Report to the Future Melbourne (Planning) Committee

**Ministerial Planning Referral TPM-2014-33
68-70 Dorcas Street, Southbank**

11 November 2014

PLANNING REPORT MINISTERIAL REFERRAL

Level 02-03
Podium Apartments & Car Park

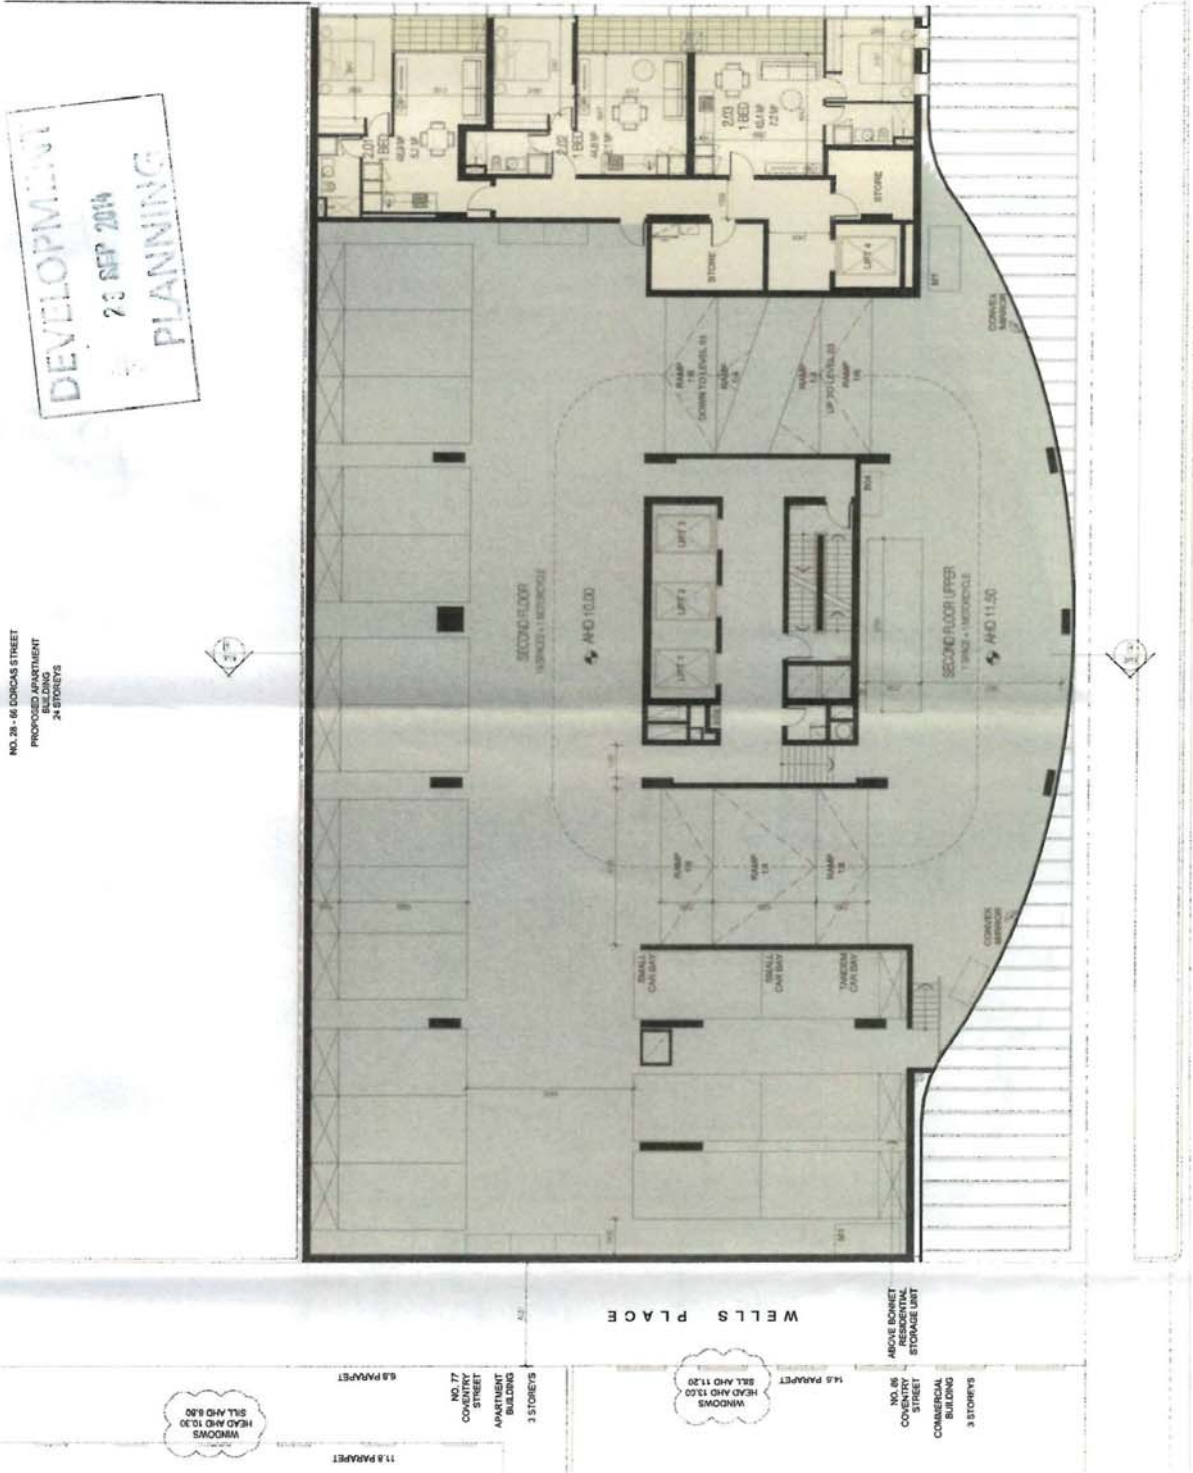
At ground floor level to Dorcas and Dodds Streets, the building presents visually interesting, pedestrian oriented facades, largely occupied by active uses. The car park however presents 4 inactive levels to Dodds Street, which will negatively impact on the character and passive surveillance of the public realm.

Level 06 - 11
14 Apartments

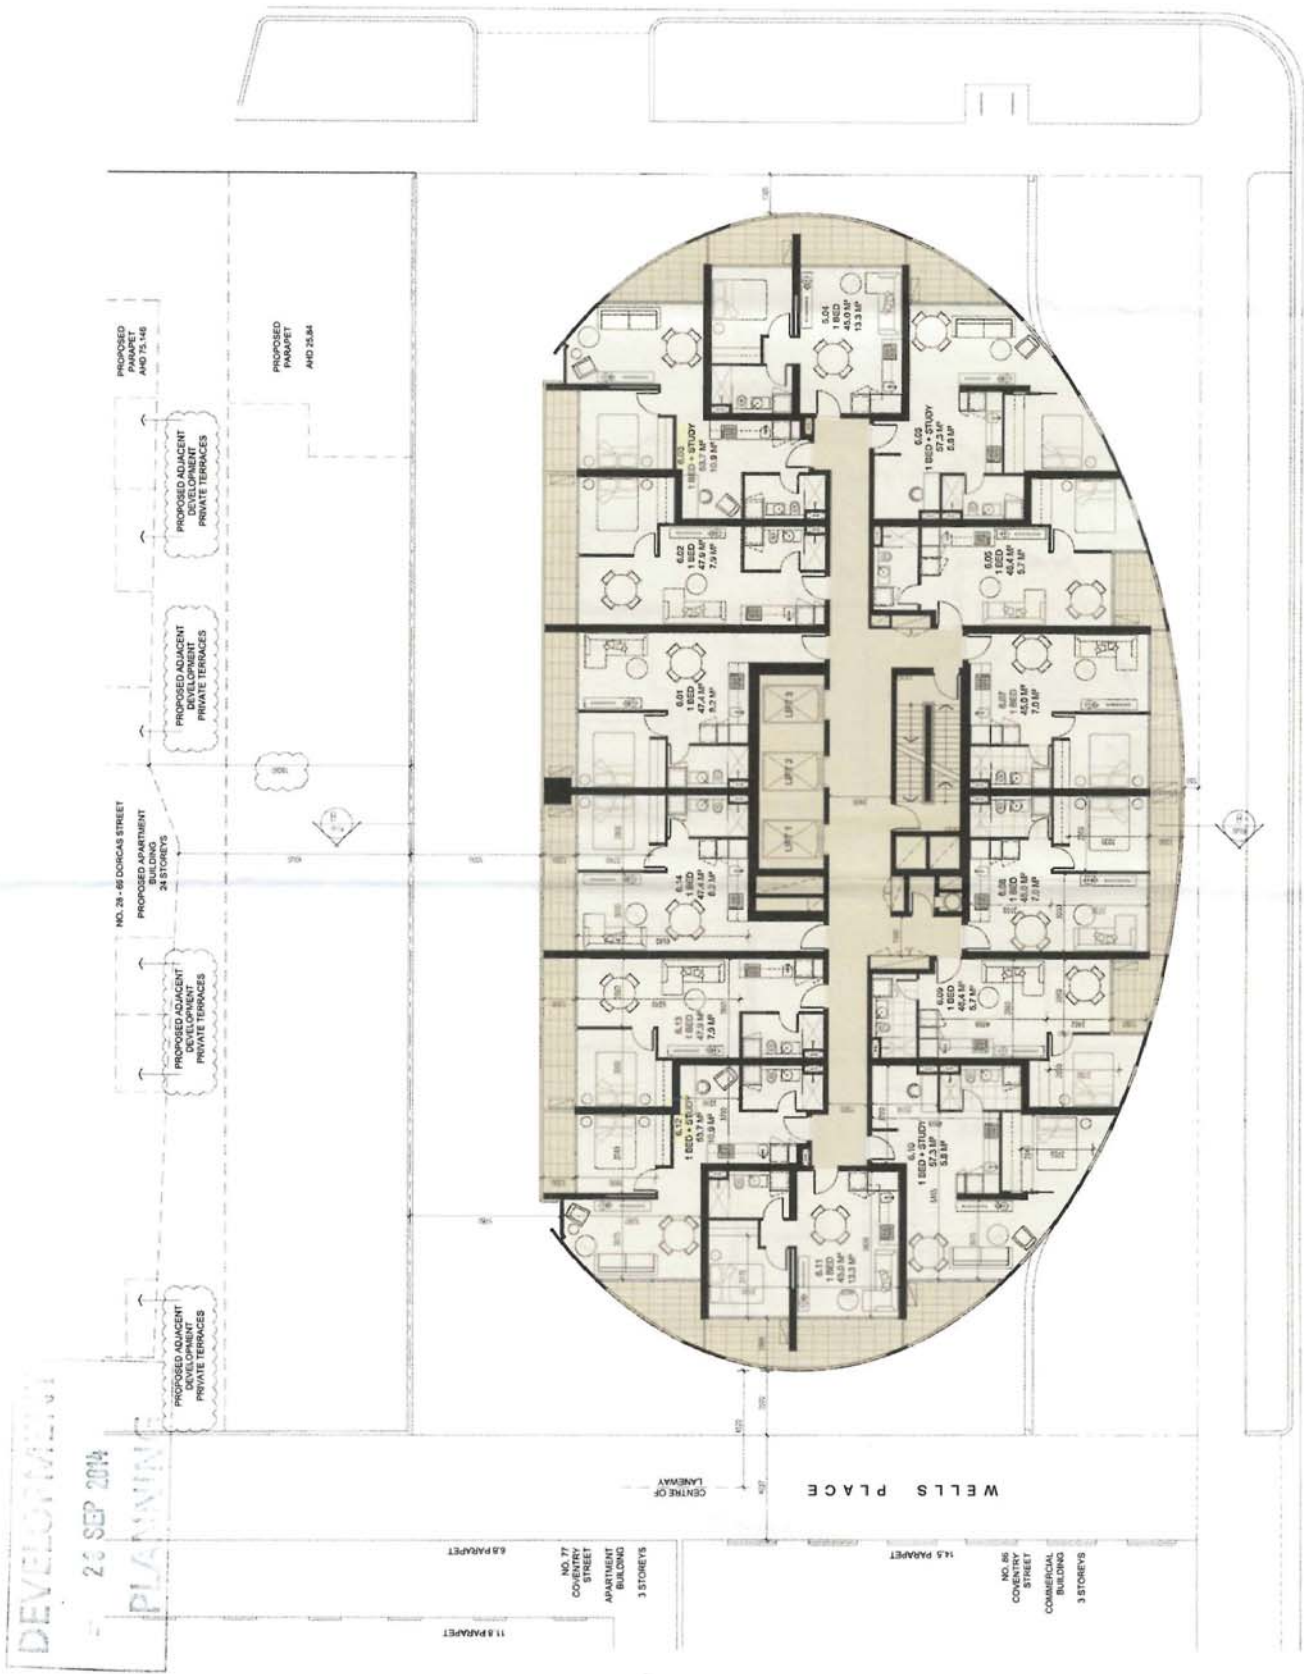
At level 5 and above the facade to the north, south and west elevations is curved, resulting in varied setbacks from these boundaries. Tower setbacks are a minimum of 2500 mm from the north boundary, 1500 mm from the south, 550 mm from the west and 5000 mm from the east. The following comments are provided regarding tower setbacks.

A fundamental principle of DDO 60 is that towers should be set back at least 10 m from all boundaries, but not less than 5 m. The DDO envisages a situation where tower residents will benefit from sunlight, daylight and outlook from all sides of the tower. This cannot be achieved if setbacks are inadequate. The proposed setback does not adequately consider the equitable development potential of the site to the north, as required by the relevant built form outcome under DDO 60.

The tower is set back a minimum of 1500 mm from the south boundary (Dorcas Street) and 550 mm from the west (Dodds Street). With regard to street frontages, the requirement of DDO 60 for minimum tower setbacks of 10 m is to ensure that large buildings do not dominate the urban form at ground level.

North Elevation

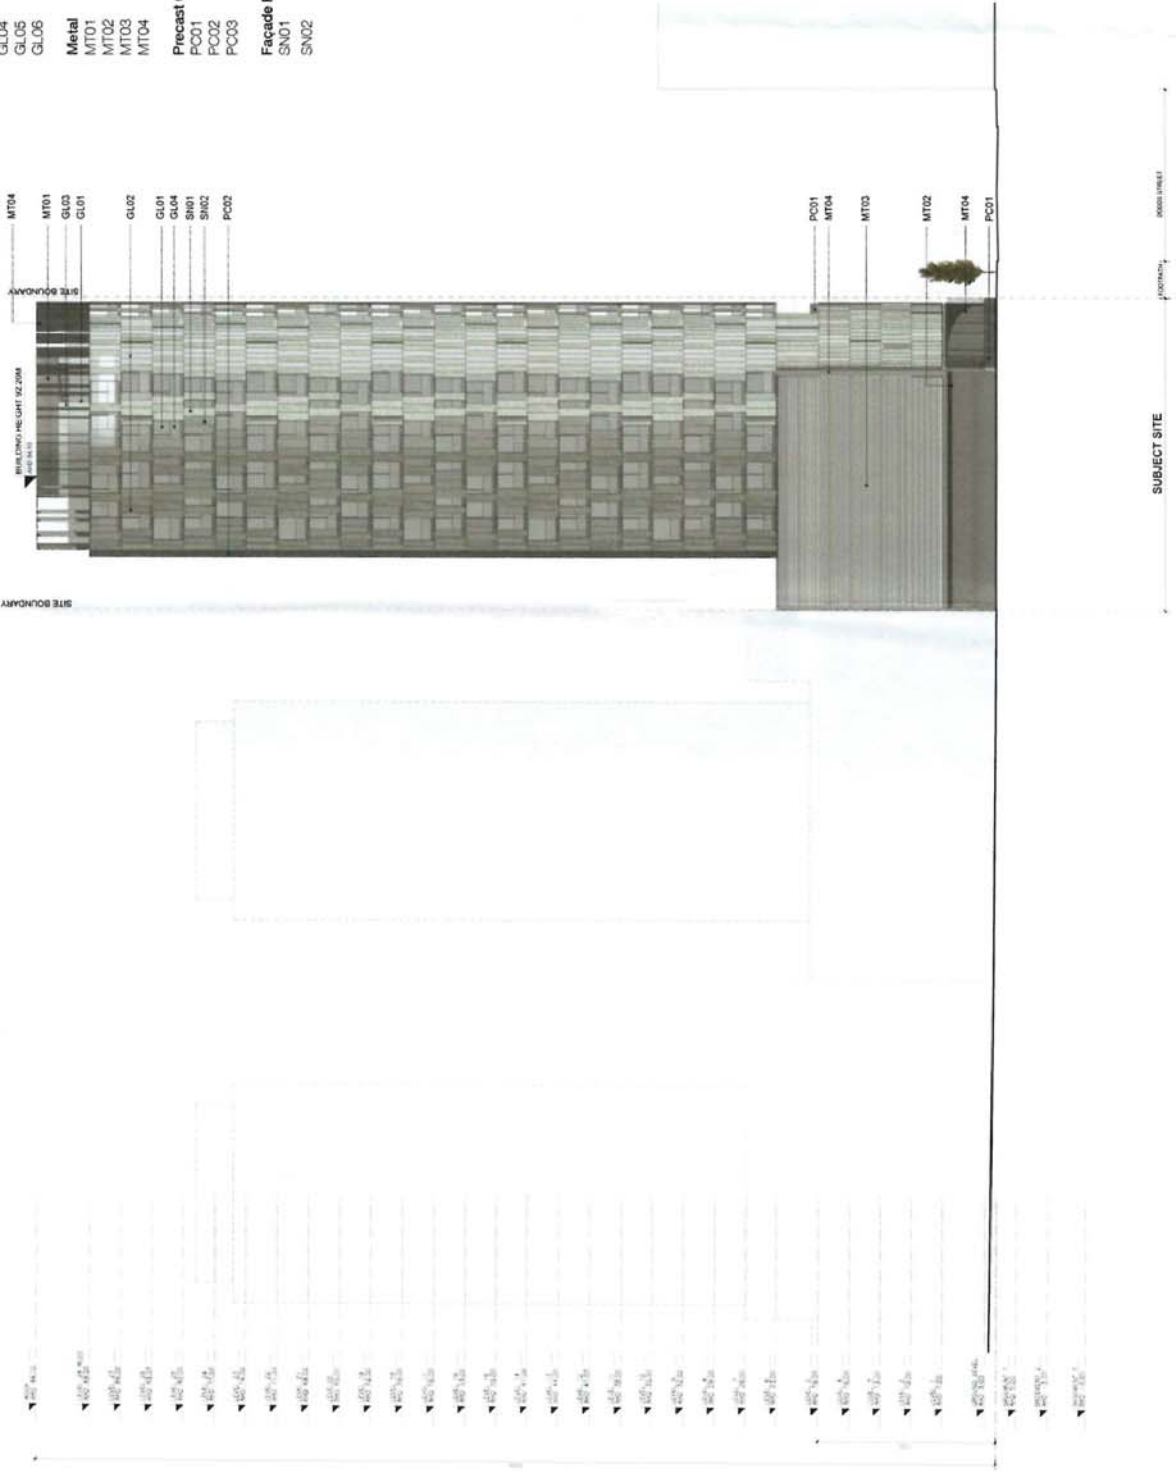
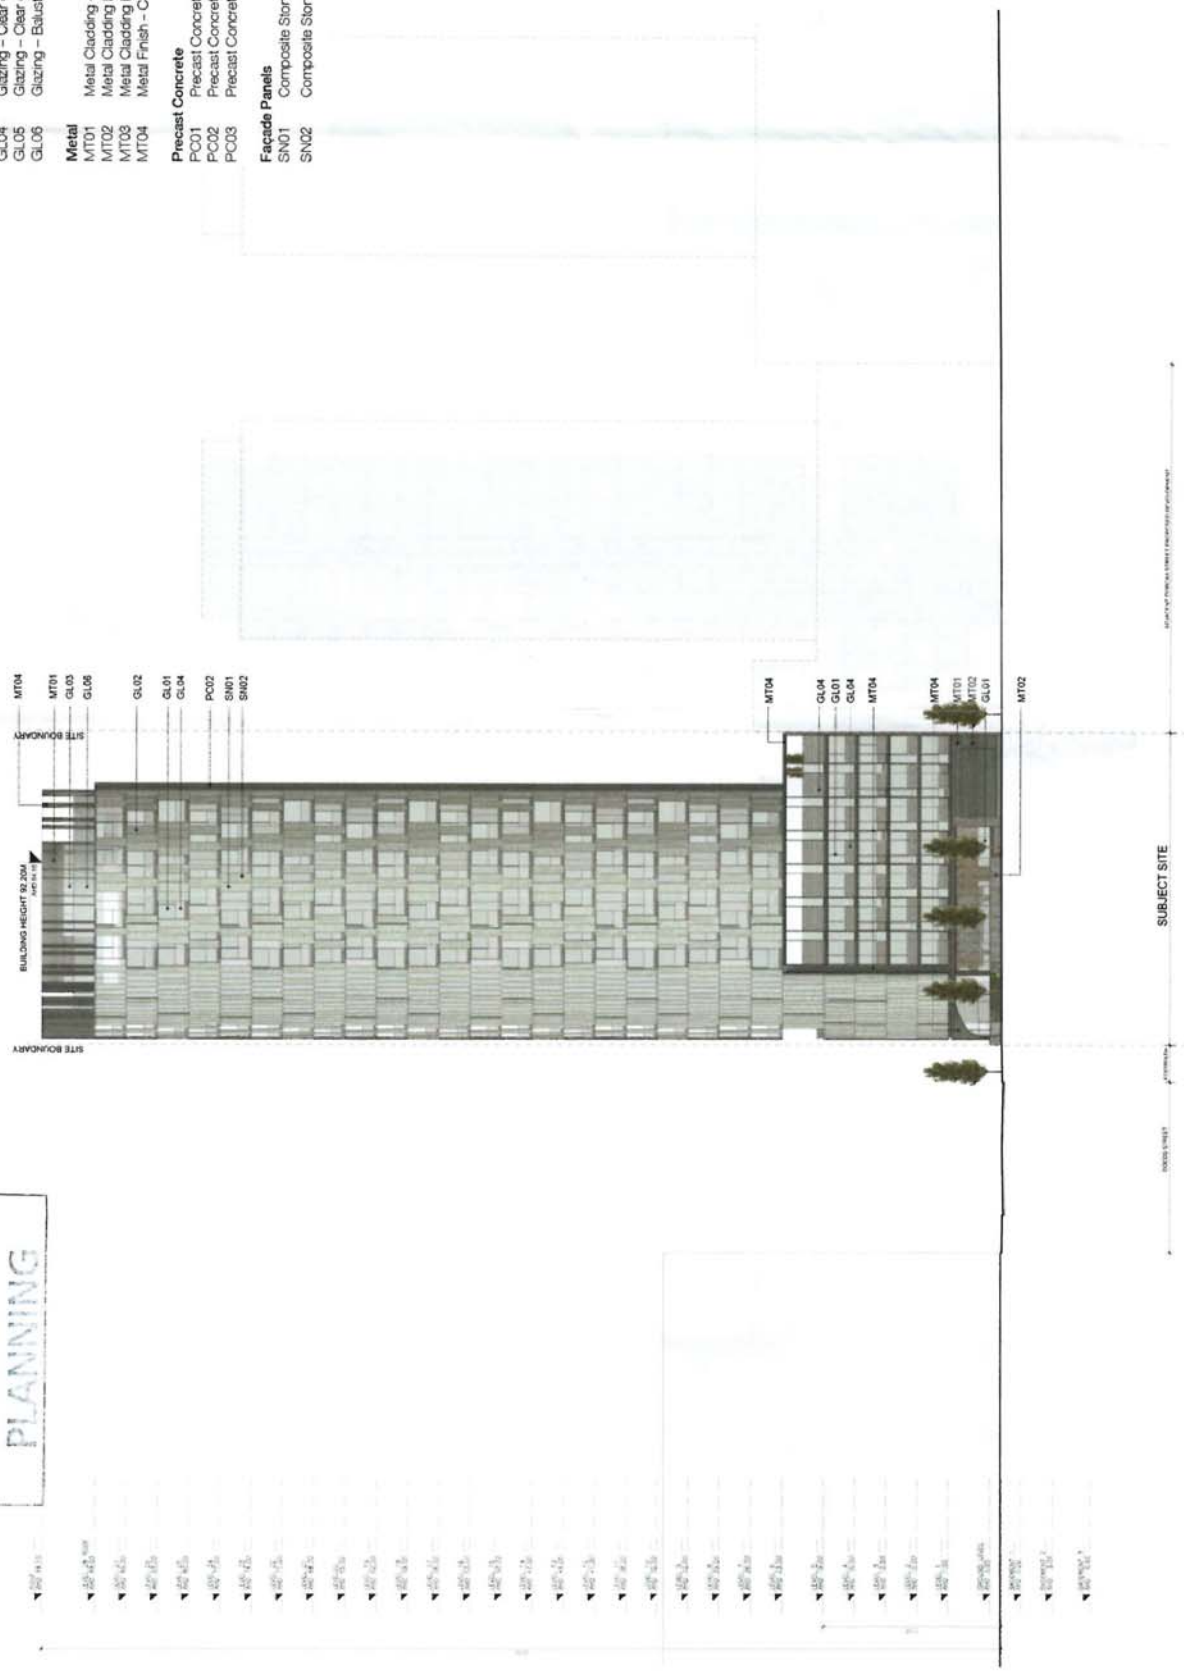
The elevations are generally well designed and articulated. They feature a variety of glass types, metal cladding and balconies which serve to create visually interesting facades.

To Wells Place, the car park levels present a metal louvre wall facing the lane. Ideally, these levels would feature a 'sleeve' of active uses. As a minimum, a facade providing a greater degree of visual interest should be provided.
